SERVICE BULLETIN

ENGINE INDICATING - ENGINE - IGNITION - INCORPORATE AN EGT HARNESS AND JUNCTION BOX FEATURING IMPROVED WIRING BETWEEN THE ELECTRONIC ENGINE CONTROL (EEC) CHANNELS - CATEGORY CODE 7 - MOD.ENG-77-0004

V2500-ENG-77-0004

Location of EGT Harness and Junction Box
Fig.1

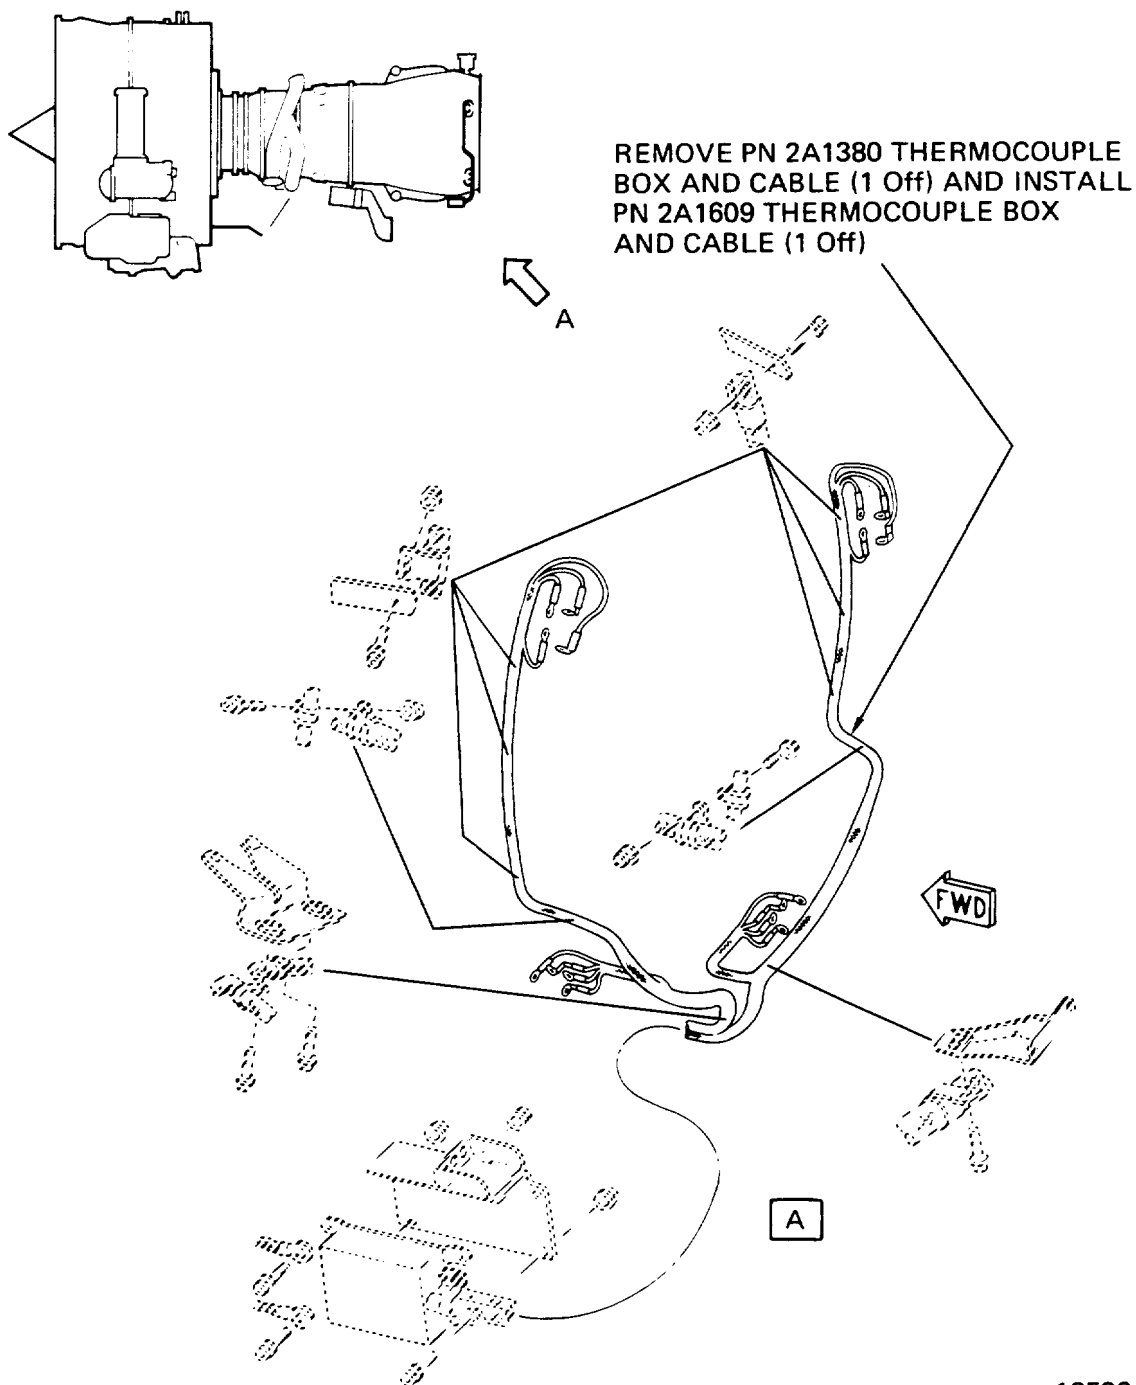
- (1) The EGT Harness and Junction Box is replaced to get a closer T4.9 Thermocouple Average Comparison between control channels.

- (1) Replace the 2A1380 Thermocouple Box and Cable (1 off) with the 2A1609 Thermocouple Box and Cable (1 off) by the approved procedures in Reference (2), and Reference (3), Chapter/Section 72-00-50 Installation-07.
